Re: Docket No. 50-275, OL-DPR-80
Docket No. 50-323, OL-DPR-82
Diablo Canyon Units 1 and 2
Revised Response to IEIR 50-275/87-19 and 50-323/87-19
Safeguards Notice of Violation

Revised Response to IEIR 50-275/87-19 AND 50-323/87-19
Safeguards Notice of Violation

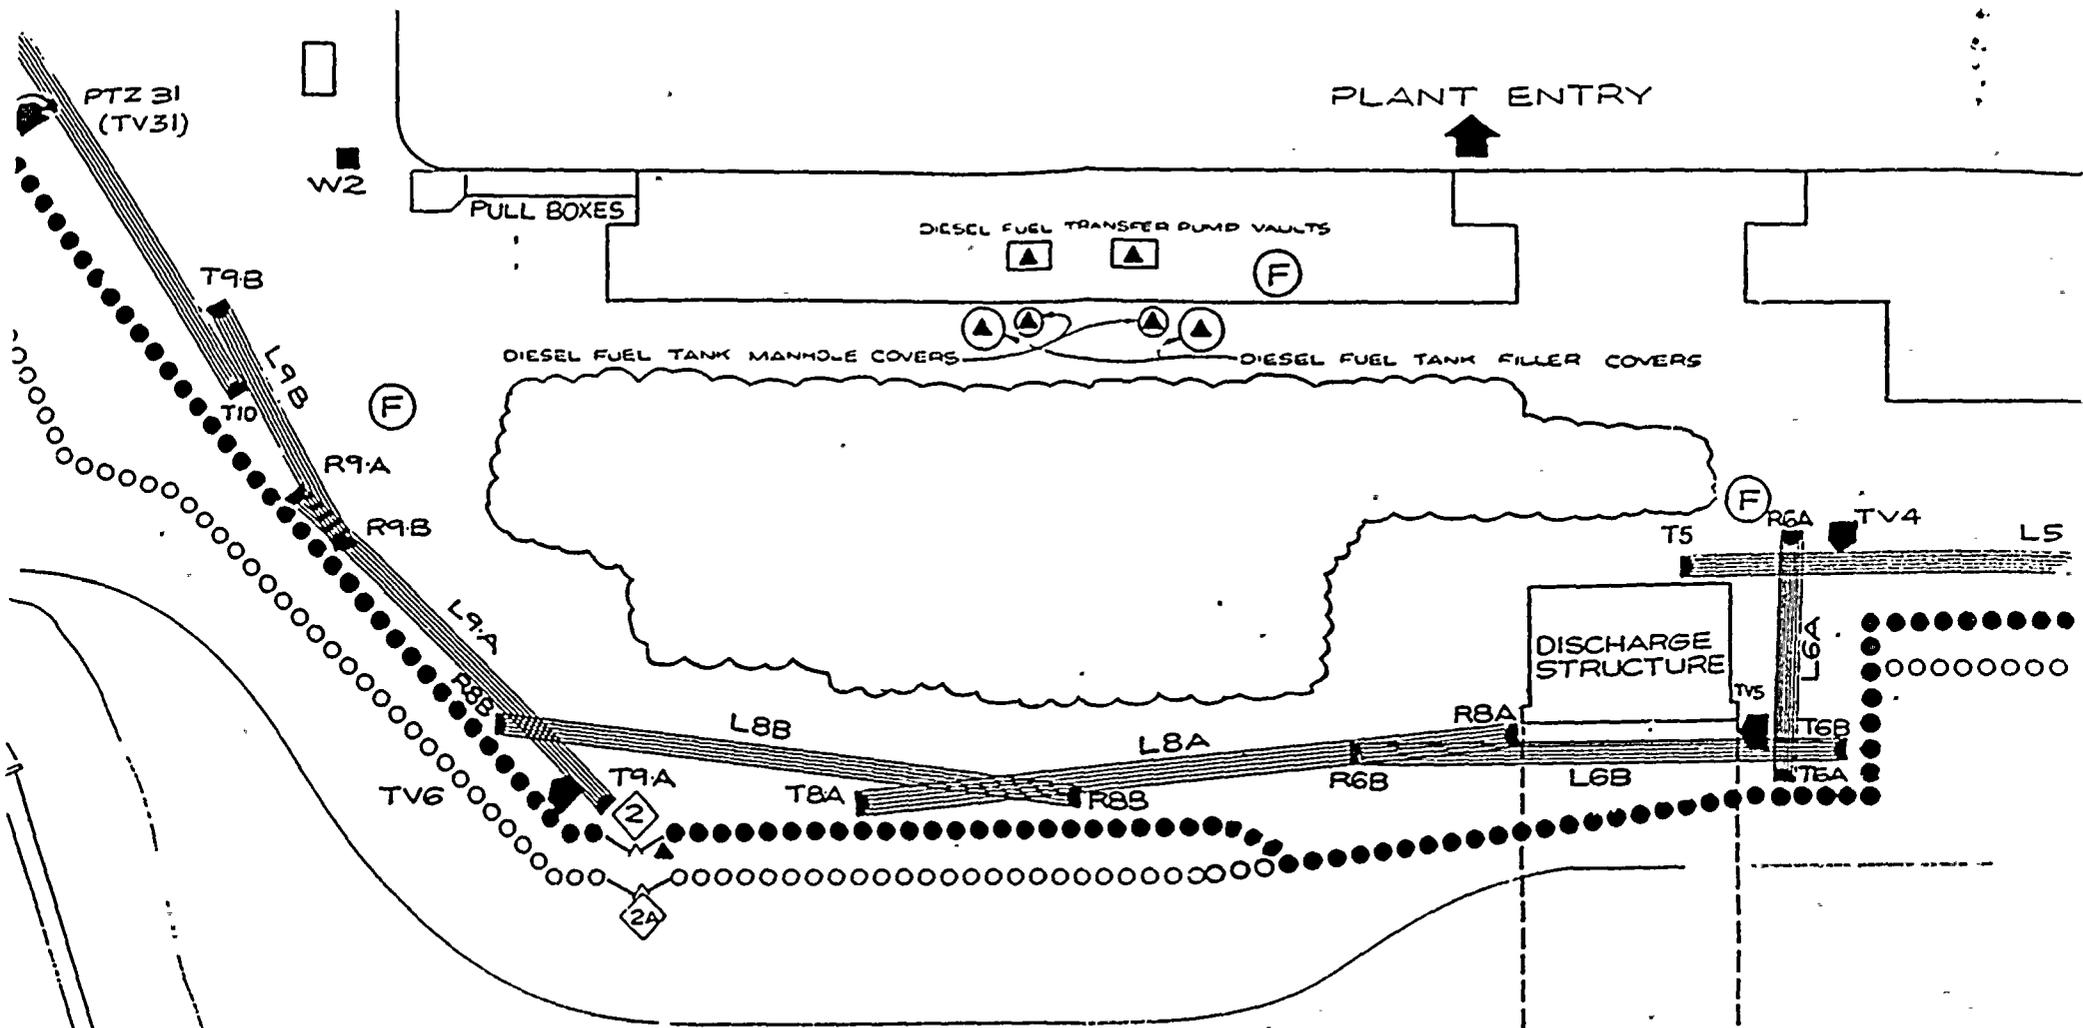
Contrary to the above, on May 4, 1987, there were four separate areas (totaling approximately 110 feet) along the protected area perimeter which were not capable of being viewed by any of the CCTV cameras. As a result, the video consoles in the CAS and SAS were unable to view these four separate areas of the plant perimeter.

1. CCTV Camera 4 has been realigned and now views the fence line south of the discharge structure.
2. CCTV Camera 5 in front of the discharge structure has been realigned to improve fence line observation. A gap in CCTV coverage still exists in this area, however, an appropriate compensatory measure has been taken until permanent corrective action is completed.
3. The angle in the fence line north of CCTV Camera 5 has been removed, thus, this section of fence line is now under CCTV observation.
4. CCTV Camera 6 has been realigned and now covers the gap at the base of CCTV Camera 31.

NOTE: Refer to the attached figure which reflects the changes identified above.
